From: Kai Penny <kai@whaleback.co.uk>
Sent: 17 June 2026 16:42:22 UTC+01:00
To: "Hamish Evans" <Hamish.Evans@midsussex.gov.uk>
Subject: Re: HE Consultation Response: DM/25/1705; DM/25/1706 - Sunte House, Birchen Lane, Haywards Heath, West Sussex RH16 1RZ

Further to the revised drawings, please find below the applicant's design and heritage response to proposed changes.

Main House Hallway

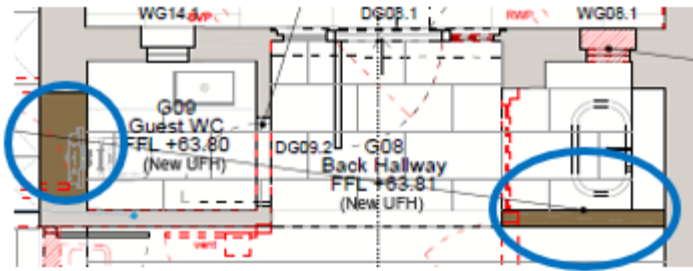
In response to Emily's comments, the revised proposals seek to preserve surviving 19th Century fabric, with the nib wall between the kitchen and the proposed hallway now retained. New door D.G07.1 has been created through the removal of modern infill elements, minimising intervention to the 19th-century fabric and enhancing the legibility and appreciation of the historic fabric through the removal of intrusive later alterations.

The infilling of the larger entrance and proposed partition wall would replicate former wall lines that existed in these locations prior to 1987, thereby re-establishing part of the historic plan form in this part of the listed building.

Overall, these revisions ensure that the legibility of the historic fabric is preserved, constitutes a small amount of new fabric (one partition and one infill in an area already heavily altered) and, by reinstating walls according to their former positions, would enhance an understanding of the building's historic plan form. As such, the proposals would both conserve and enhance the significance of the listed building.
